IN THE SPECIFICATION:

The below amendments have been made to the original specification filed in the international application and appear in the attached "substitute specification". Please replace the attached substitute specification for the original specification filed in the above-identified international application.

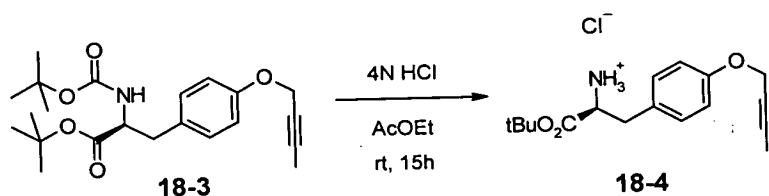
1. In the reaction scheme as described at line 1 on page 59, please replace "overnight" with "15 h" as supported by the description at line 6 on the same page.

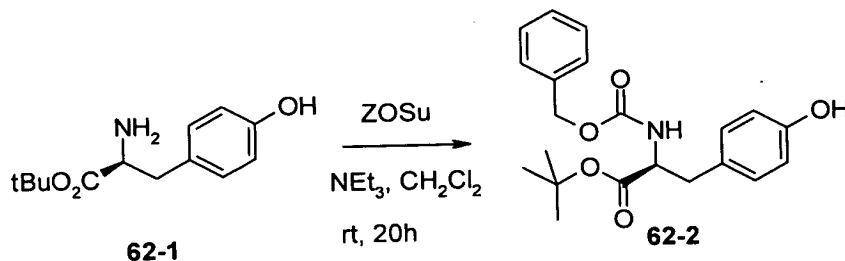
2. In the reaction scheme as described at line 25 on page 59, please replace "overnight" with "15 h" as supported by the description at line 3 on page 60.

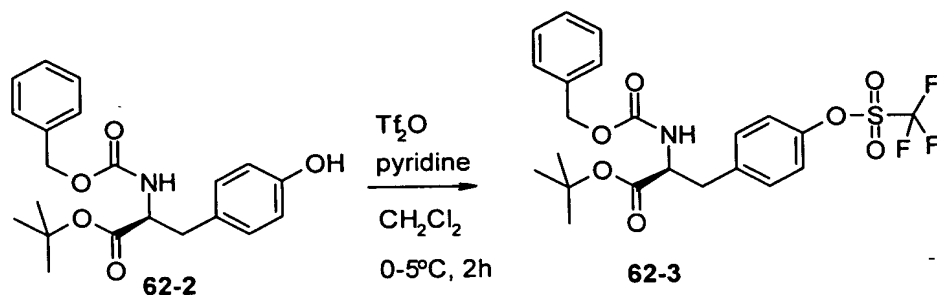
3. In the reaction scheme as described at line 11 on page 84, please replace "2 h" with "20 h" as supported by the description at line 16 on the same page.

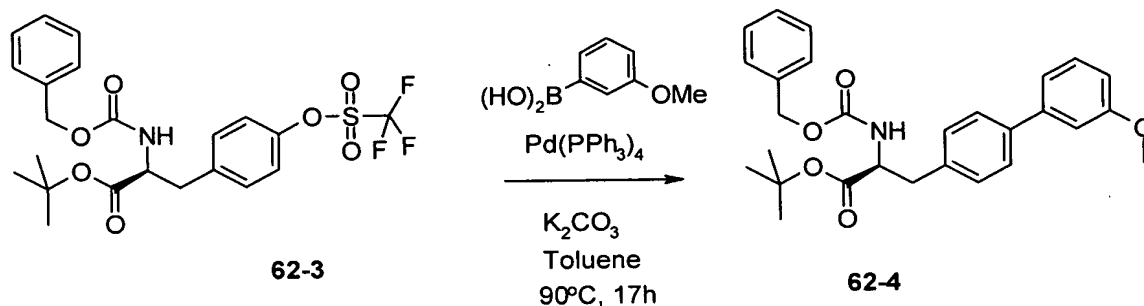
4. In the reaction scheme as described at line 8 on page 85, please replace "0□, 1 h" with "0-5 □, 2 h" as supported by the description at lines 11 to 14 on the same page.

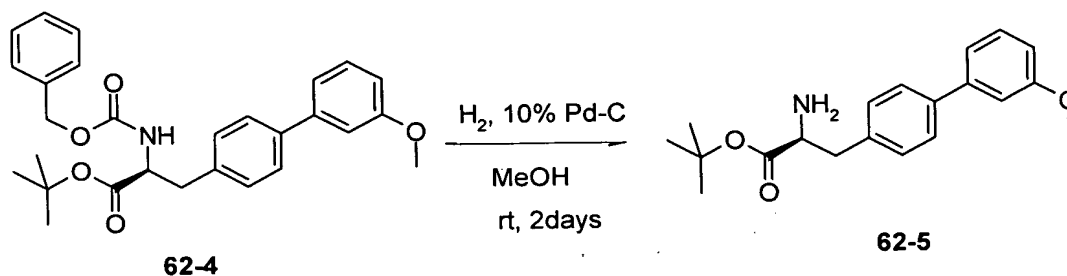
5. In the reaction scheme as described at line 3 on page 86, please replace "9 h" with "17 h" as supported by the description at line 9 on the same page.

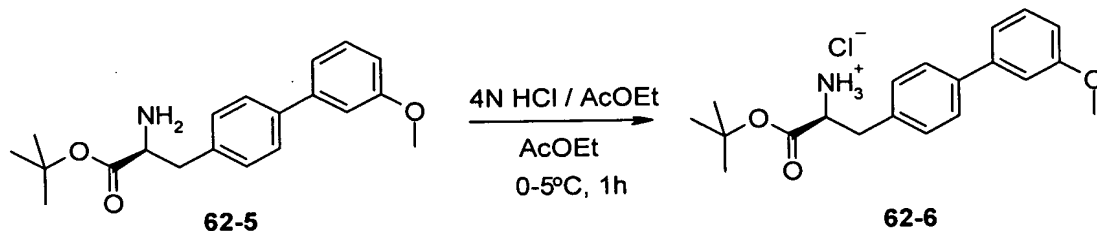
6. In the reaction scheme as described at line 1 on page 87, please replace "3 h" with "2 days" as supported by the description at line 5 on the same page.
